Response to Submissions – SSD7388, Modification 4

Section 96(2) – 31 Wheat Road, Sydney

Figure 1- Comparison of the future building form (red) and the construction hoarding (blue).

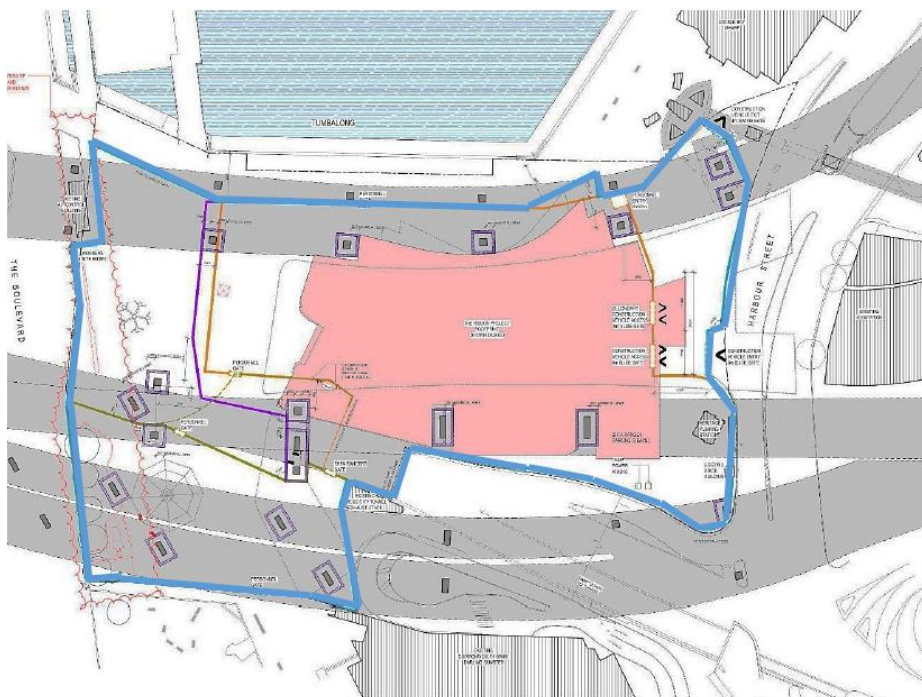
- Of specific importance to this application is the impact of the approved construction on the Property NSW public domain area around the base of the building. **Figure 1** below provides a comparison of the extent of the permanent building (red) against the approved construction zone (blue), demonstrating that there will be impacts on a significant area of public domain during the works. At the completion of works, this area will be upgraded and returned to public use. The public domain area surrounding the site is of very high importance to the functioning of the Darling Harbour area as a tourist precinct, and accordingly there are significant benefits to the greater community by reducing the construction impacts to the shortest timeframe possible.
